TRUCK UTILITY LIGHT (TUL) HS TRUCK UTILITY MEDIUM (TUM) HS AND (TUM) AMBULANCE HS

MODIFICATION INSTRUCTIONS AND INDEX

**TRUCK UTILITY LIGHT (TUL) HS
TRUCK UTILITY MEDIUM (TUM) HS
AND (TUM) AMBULANCE HS
MODIFICATION INSTRUCTION No 1**

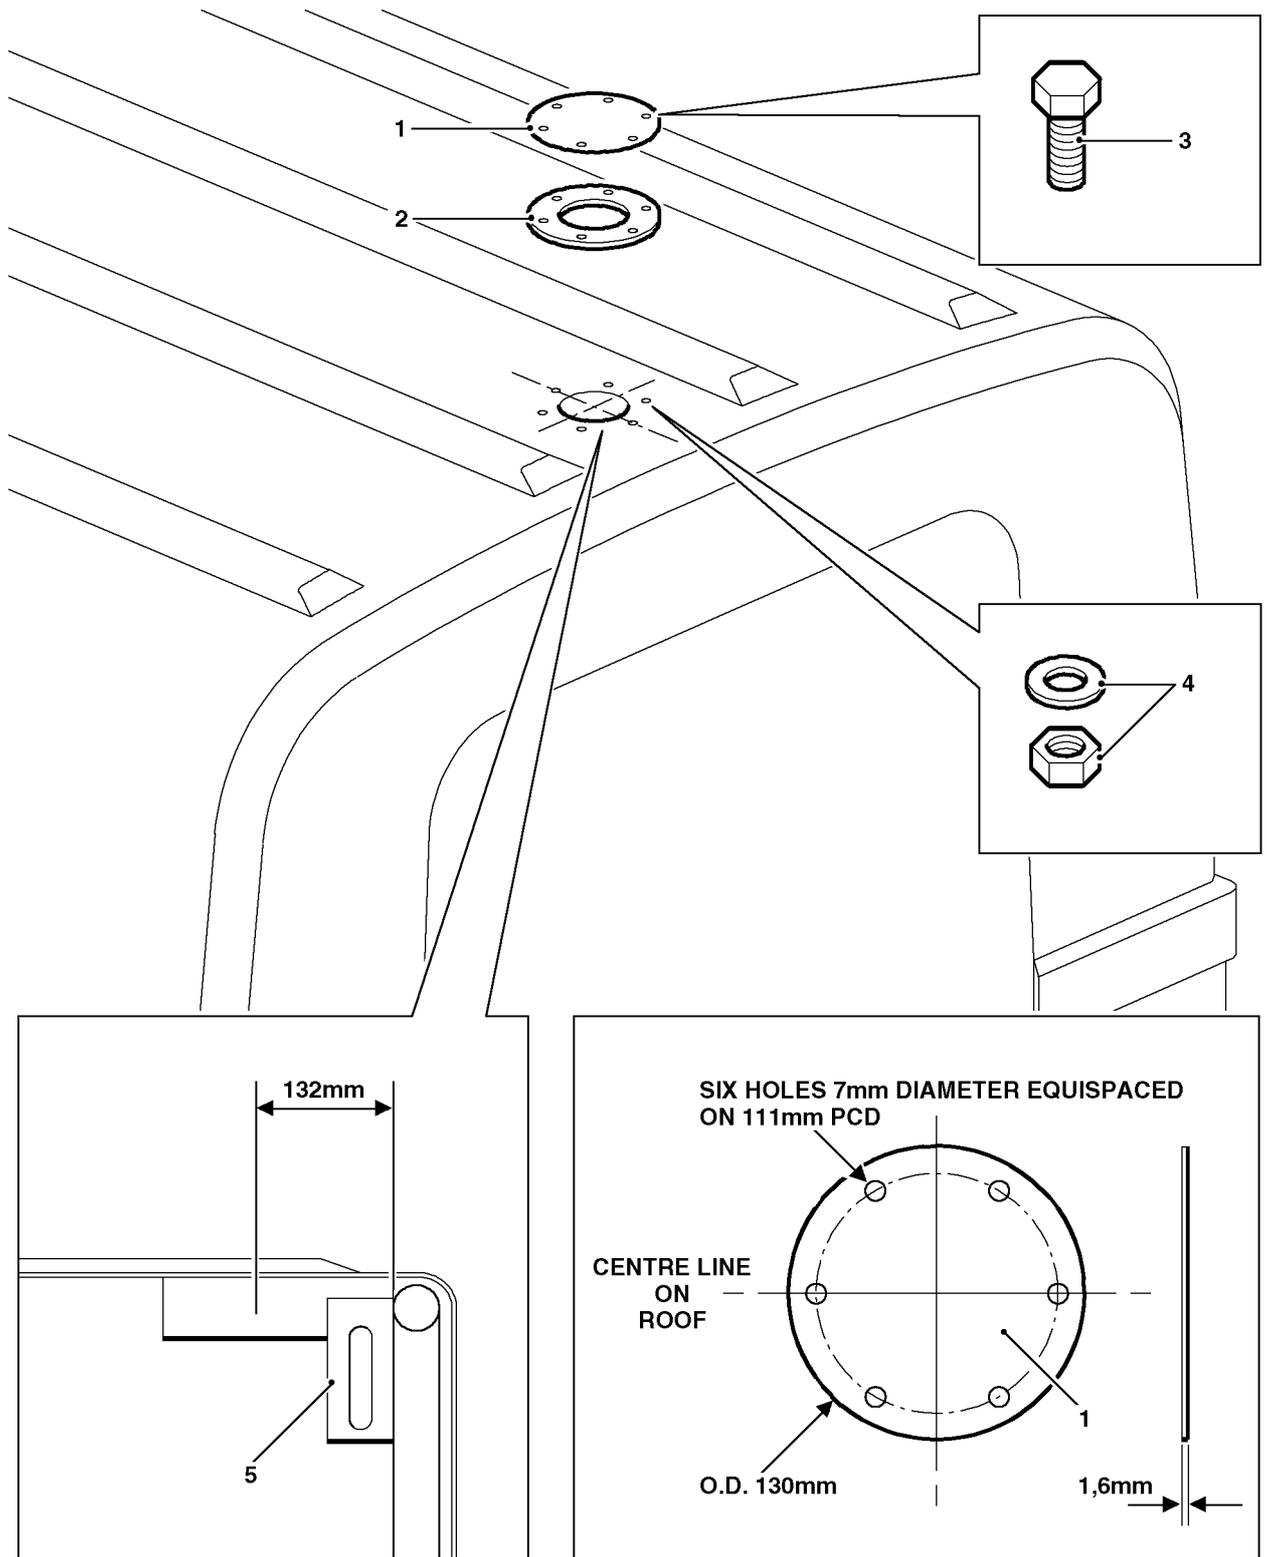
- 9.9 Drill pilot holes for the six fixing holes and follow through to the correct diameter of 7 mm.
- 9.10 Clear away all rough edges using a file or medium grade glass paper and wipe clean the area.

Fig 1 Manufacturing details

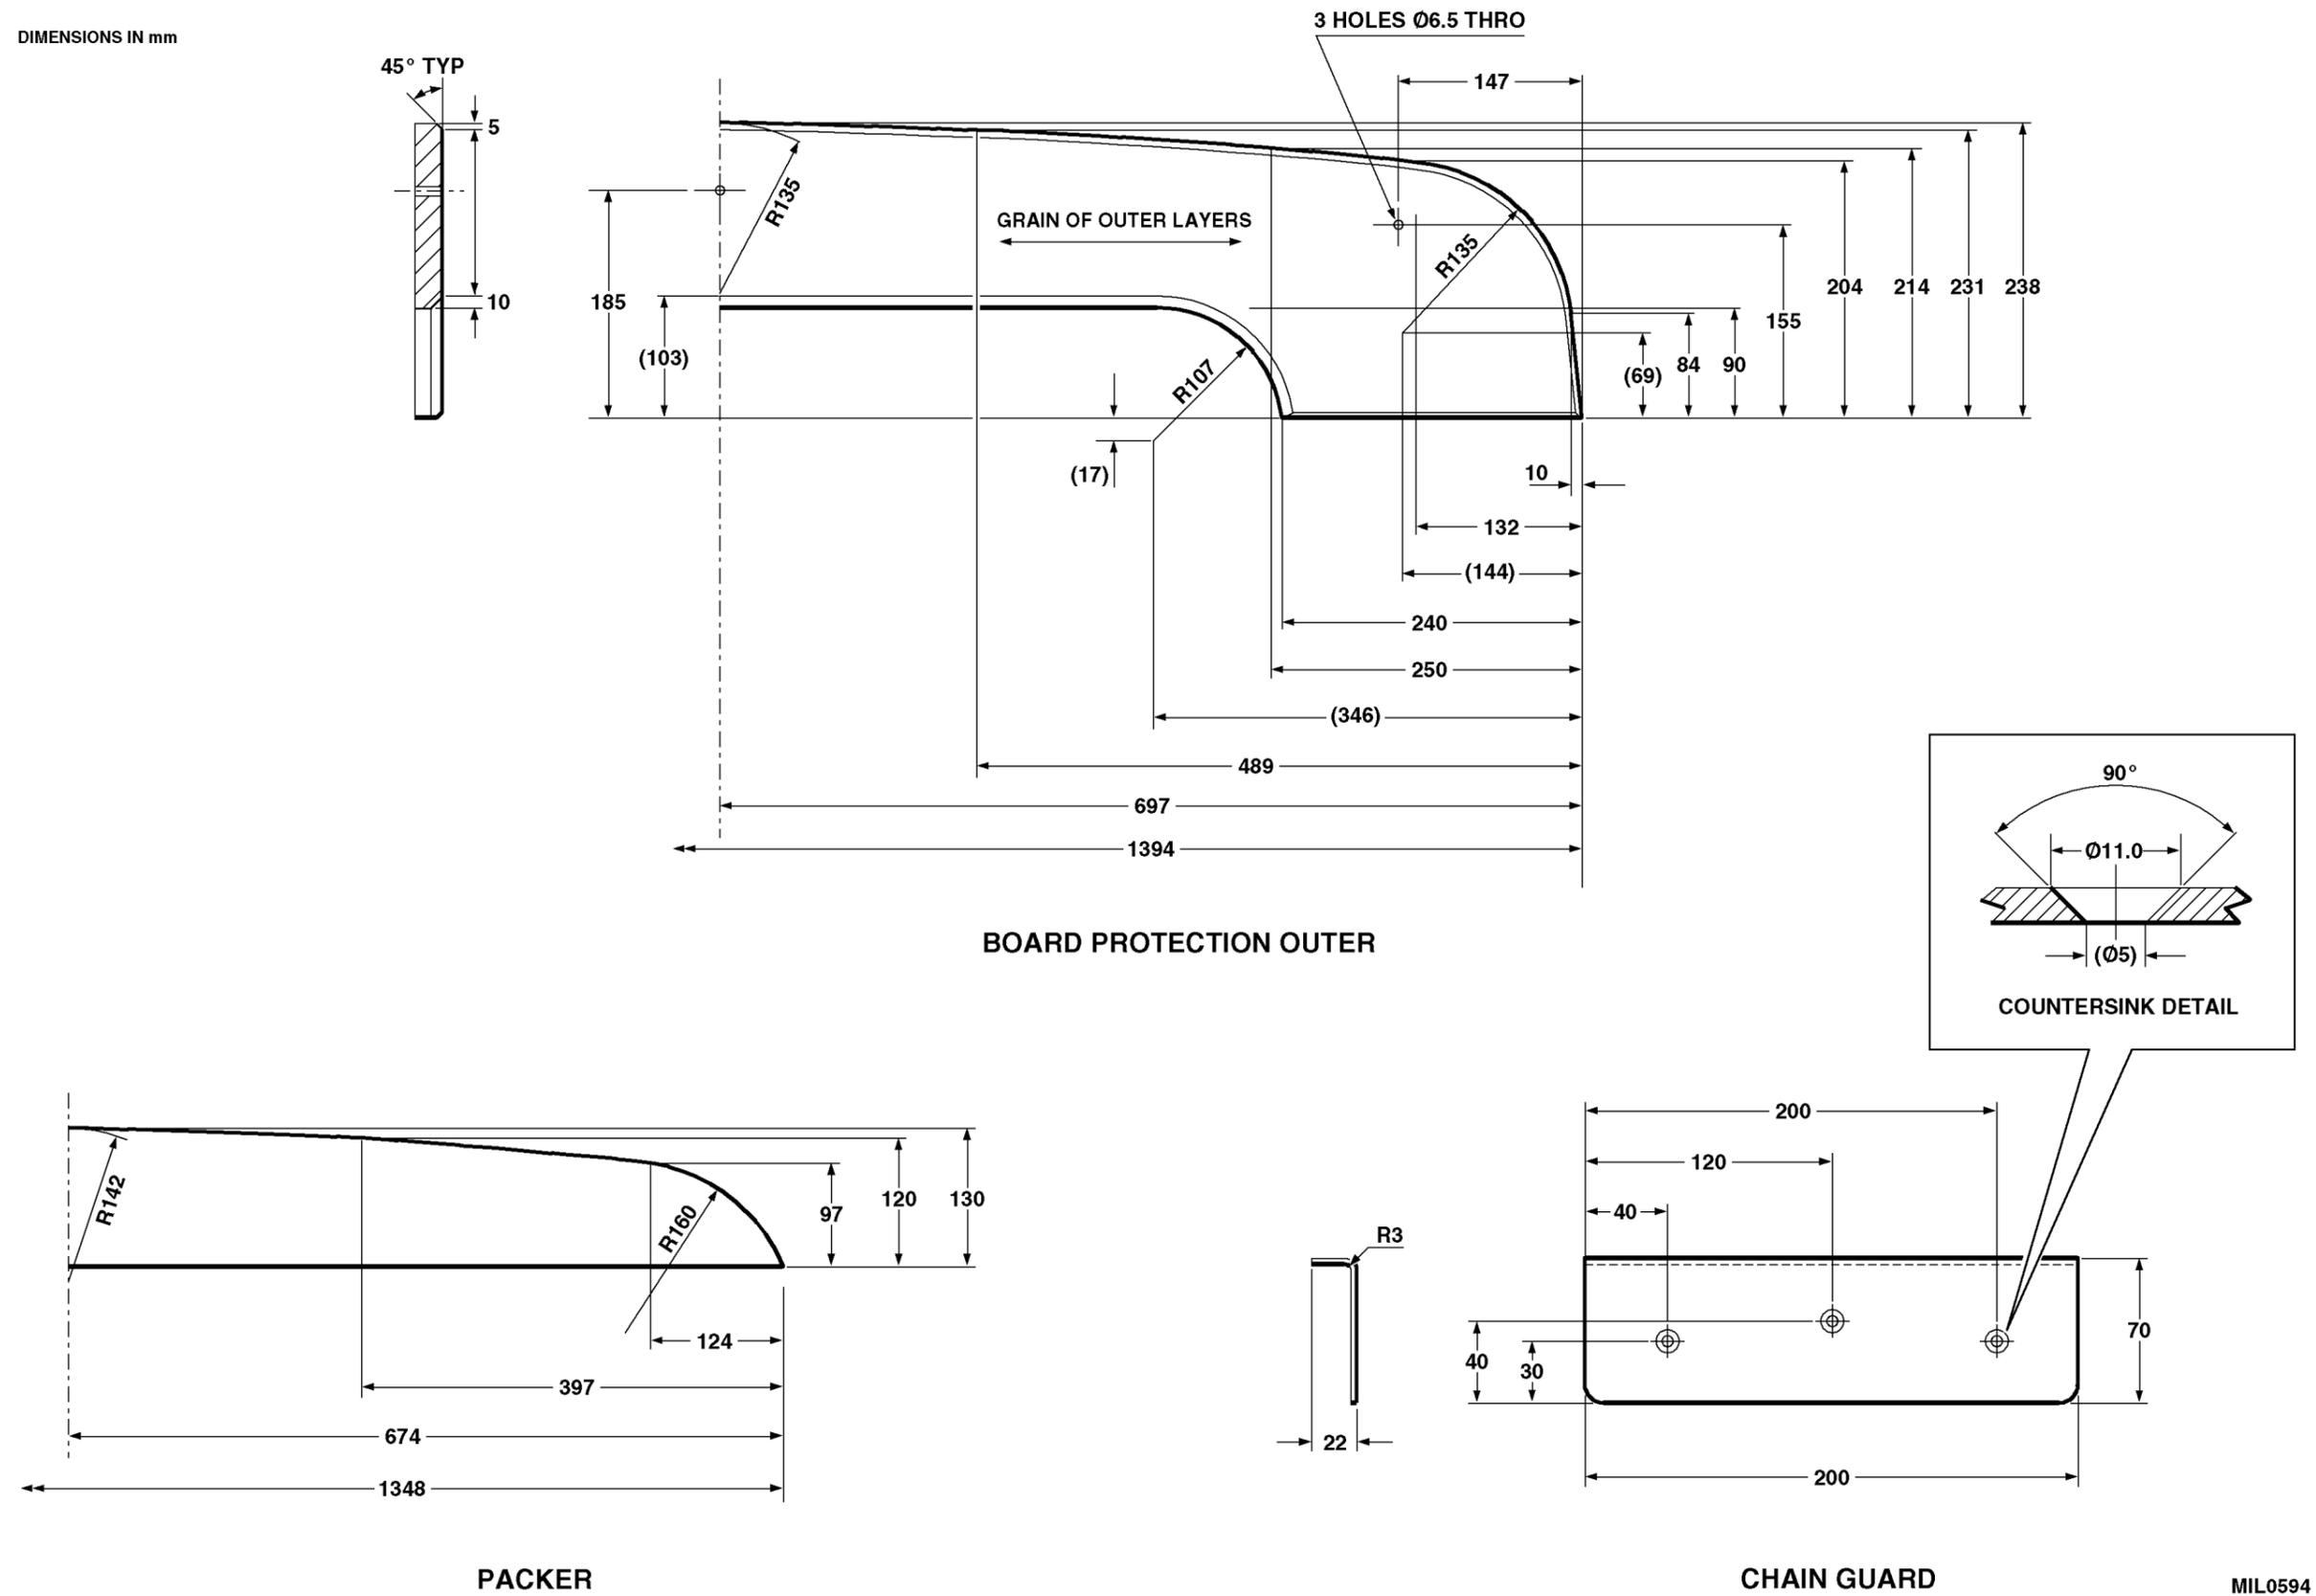
9.3.1 Fabricate chain guards from steel to BS EN 10025 S275 3 mm thick (Item 6) to detail.

Fig 3 Securing and sealing

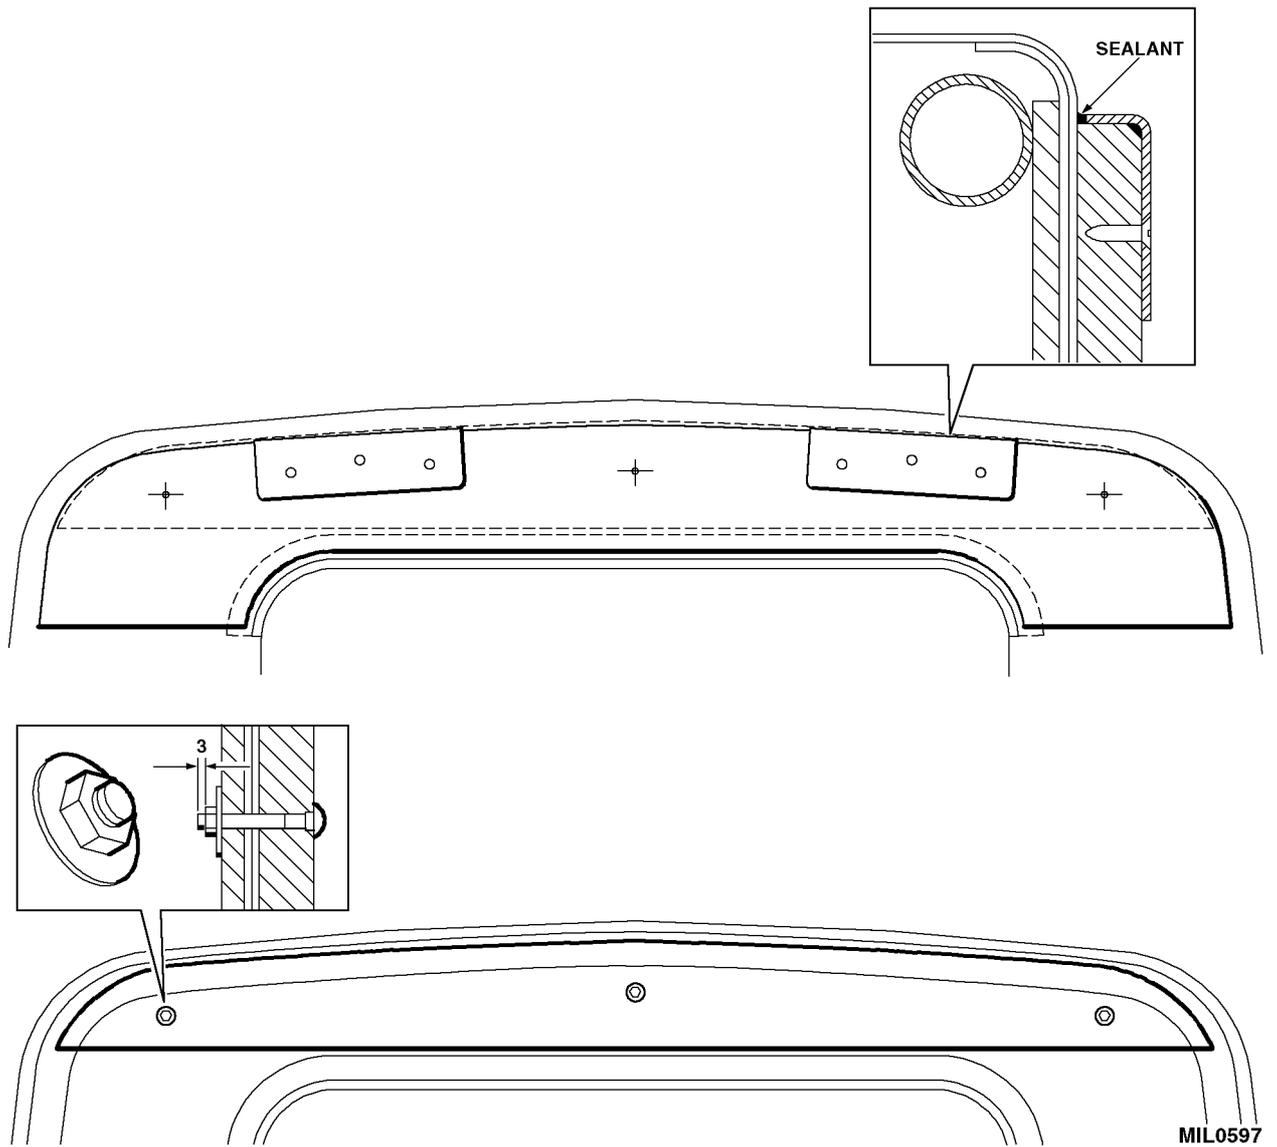
9.5.5 The bolts must not protrude from the nuts by more than 3 mm, if necessary trim the bolts to the correct length (refer to Fig 3).

9.5.6 Remove the clamps and apply sealant (item 11) between the hood and protection board along the top edge only (refer to Fig 3).

Fig 1 Drilling instruction

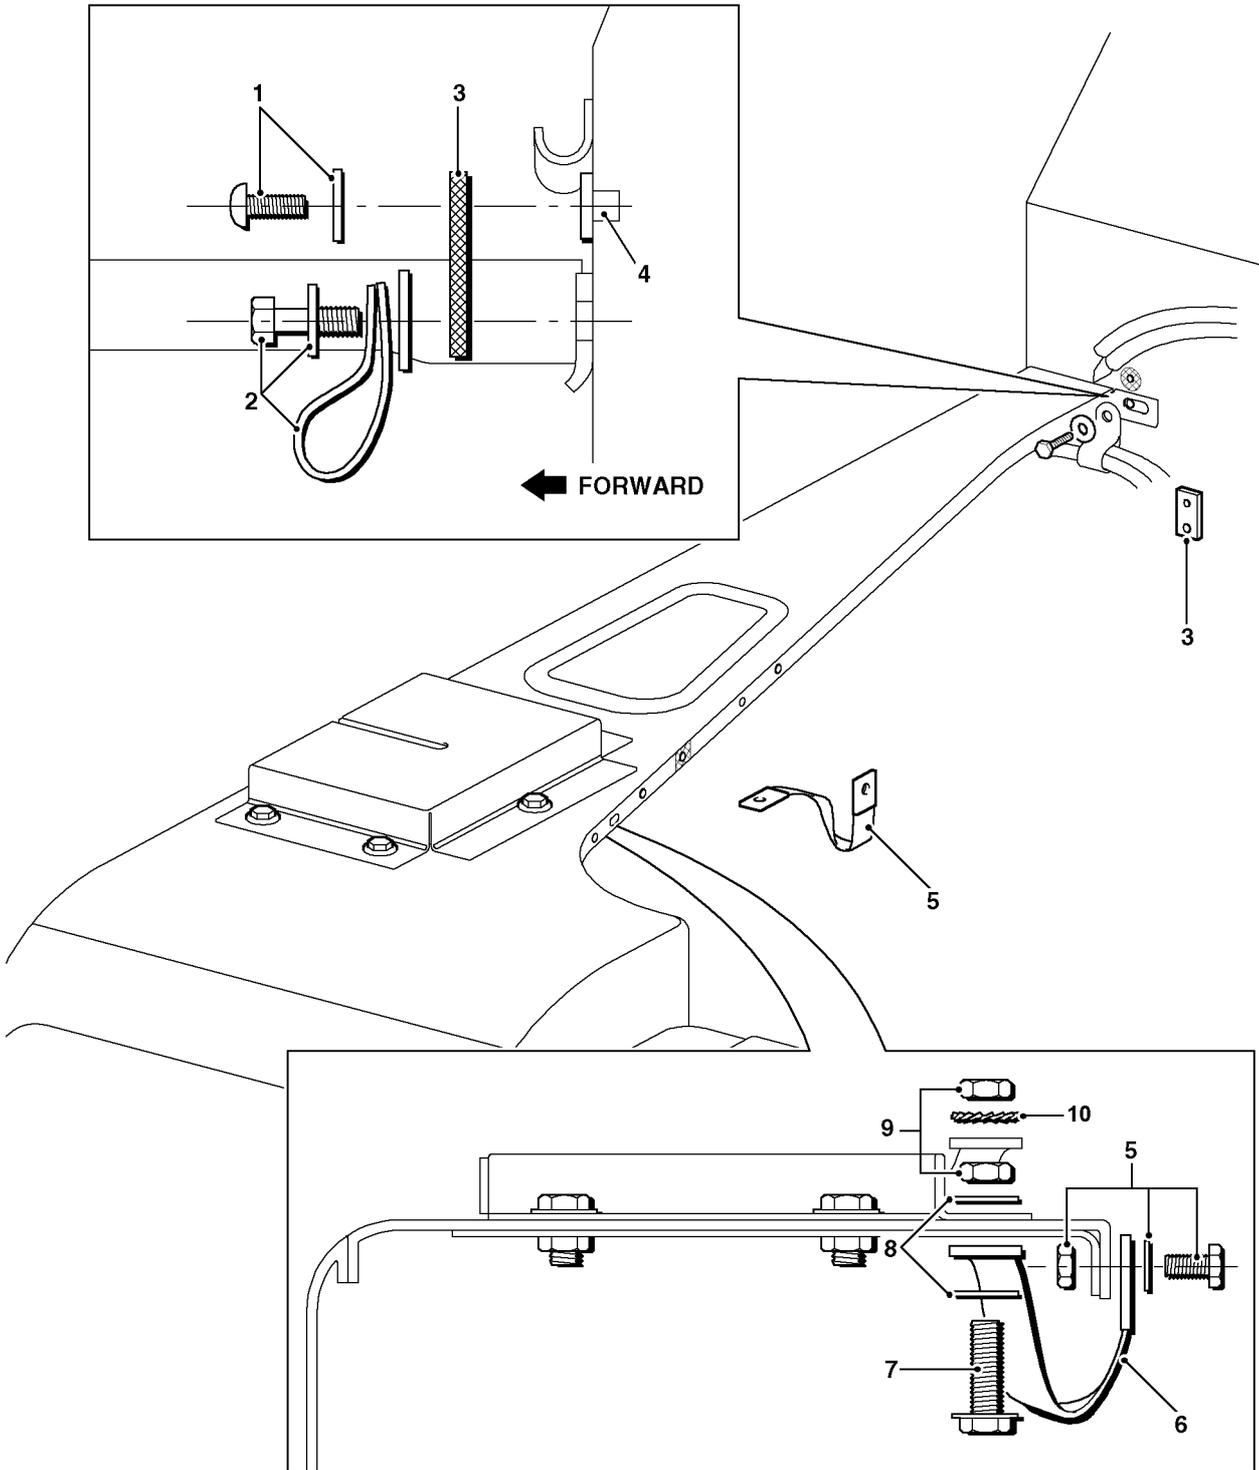
9.2.1 Remove and retain M6 fixings (2), including plastic 'P' clip, securing wing top bracket to dash.

9.2.6 Remove outer fixing from bonnet hinge and using a wire brush clean off paint from around the hole.

9.2.8 Remove M6 fixings in wing flange and discard.

9.2.11 Remove centre M8 fixings securing the TUAAM bracket to wing top and discard.

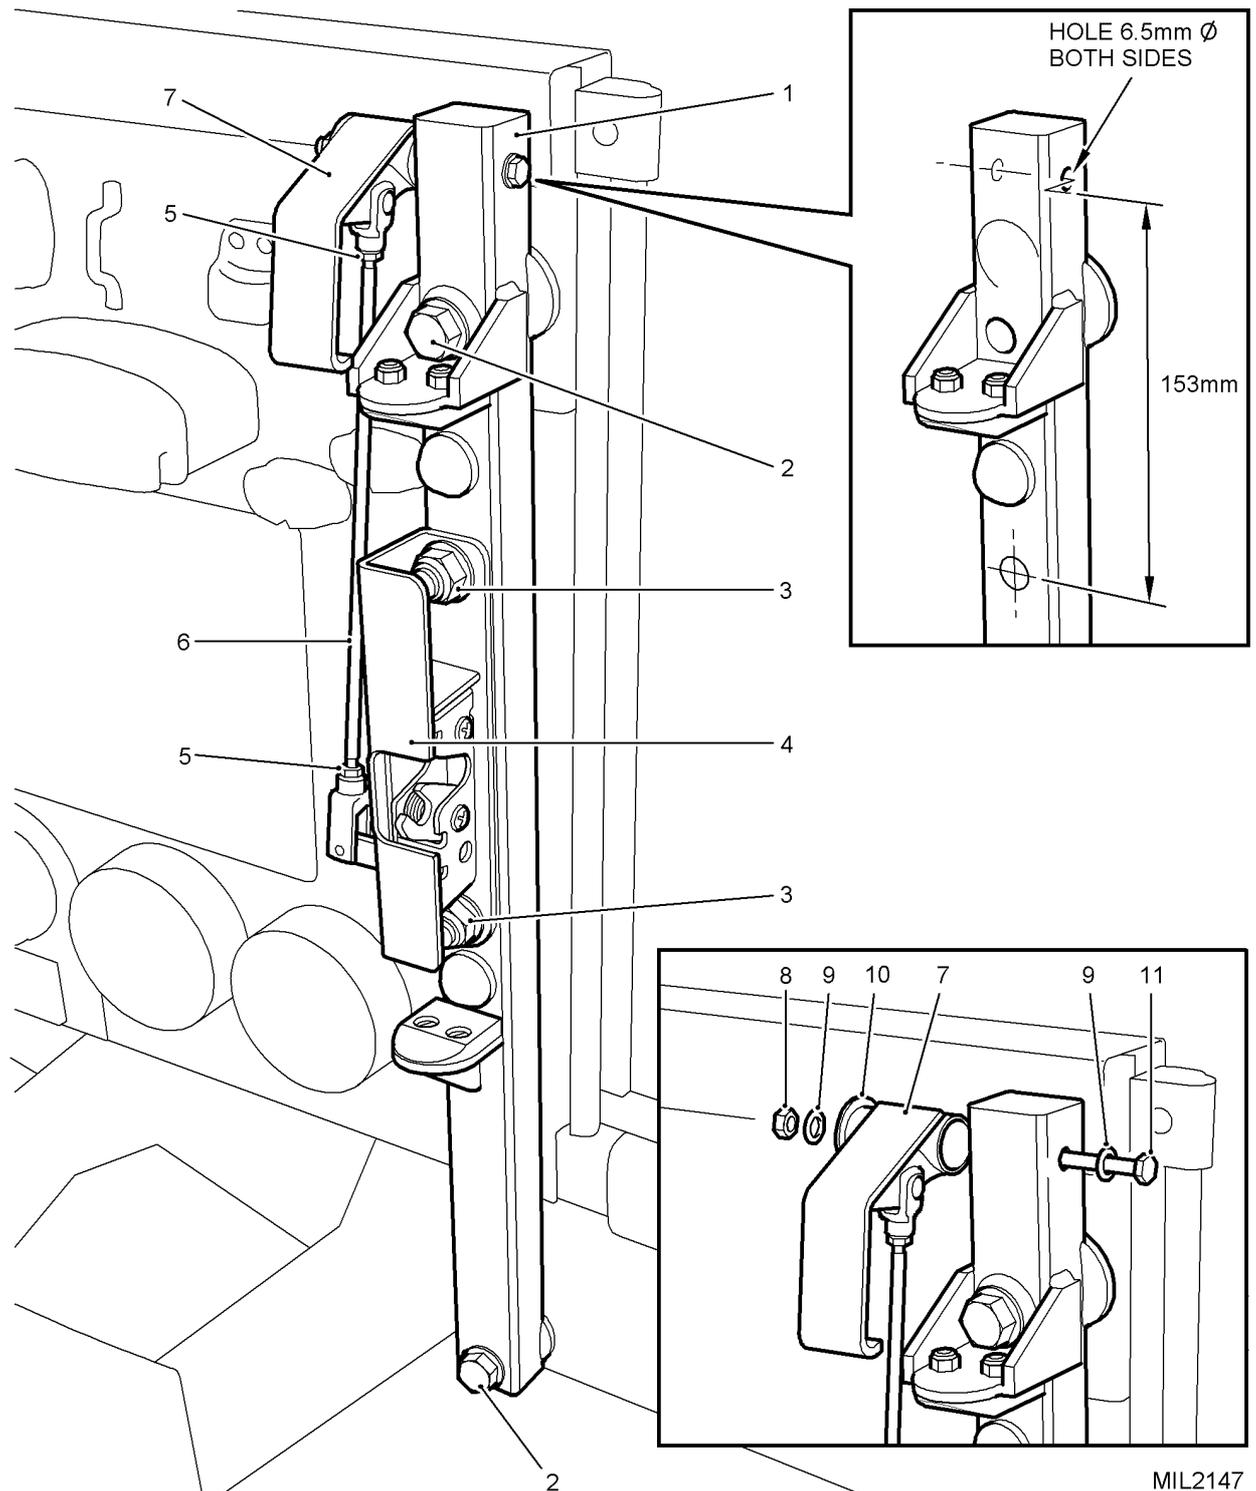
- 9.1 Remove pannier post and 'Anti-Luce' fasteners.
- 9.2 Drill \varnothing 6.5 mm hole in pannier post (refer to Fig 1) and treat with zinc primer (item 22, para 8), apply NATO Green top coat (item 23, para 8). Alternatively treat bare metal with anti-corrosive paint.

- 9.3 Fit latch mounting (item 1) to pannier post.
- 9.4 Refit pannier post.
- 9.5 Remove existing hasp plate from pannier.
- 9.6 Drill \varnothing 30 mm hole in pannier (refer to Fig 2), and treat with zinc primer (item 22, para 8), apply NATO Green top coat (item 23, para 8). Alternatively treat bare metal with anti-corrosive paint.
